of Private Plan Change 17 to the Hamilton City
Operative District Plan ("PC17")

**SUMMARY STATEMENT OF EXPERT EVIDENCE OF CAMERON BESWICK INDER
ON BEHALF OF FONterra LIMITED**

TRANSPORT

Figure 3.9.2.5.e (Indicative Old Ruffell Road cross section (Collector))

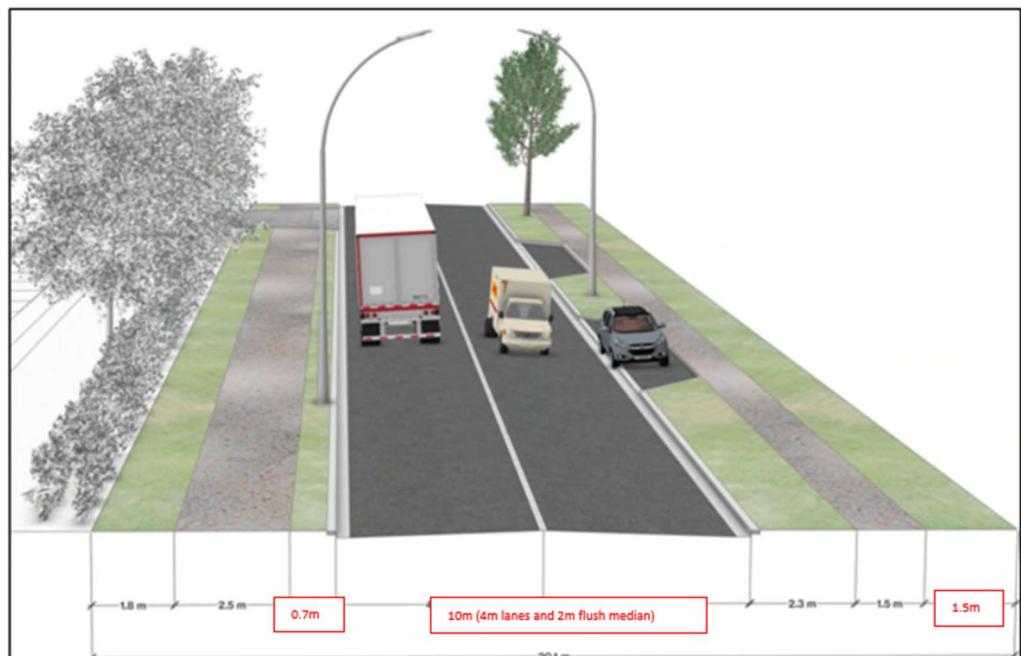
5.3 Council has also proposed amendments to Figure 3.9.2.5.e (the Indicative Old Ruffell Road upgrade cross section (Collector)), and the Infrastructure Requirement Table 3.9.3.2.a. I disagree with all but one of these amendments as explained below.

5.4 Council's proposed amendments are in red above. In my opinion, these changes add significant and unnecessary cost to this upgrade because:

- (a) Approximately 180 m of existing, relatively new kerb and channel on the southeast side of Old Ruffell Road would need to be ripped up and reconstructed (including new pavement) about 0.5m to the right of the current position.
- (b) Reducing the berm width between the boundary and the footpath on the southeast side to 1.5 m means some of the existing (significant) power poles will conflict with the new footpath location, requiring the power poles to be relocated. The 2.0 m berm width I had shown ensured the power poles remain unaffected as the new footpath would be located immediately to the left of the poles. This also

means the existing 180 m of kerb and channel discussed above (and associated catch pits and connections) would not need to be replaced.

5.5 It appears to me that the Council's proposed changes to the Old Ruffell Road cross-section have not considered the real-world implications and cost, relative to the likely benefit, which I consider is negligible in this case.

5.6 The existing constrained road reserve width (20.1 m) together with established infrastructure (power poles, and road drainage) means there is insufficient width to practically accommodate the 2.0 m flush median on this stretch of Old Ruffell Road without negatively impacting the services corridor and shared walking and cycling path widths on the northwest side as proposed.

5.7 I consider that the safety effect of excluding the central flush median and keeping the road width to 9 m between kerbs is minor because of the low number of property accesses over this relatively short stretch of road (two existing commercial vehicle crossings to established businesses on the southeast side and potentially one or two new vehicle crossings in future on the northwest side.
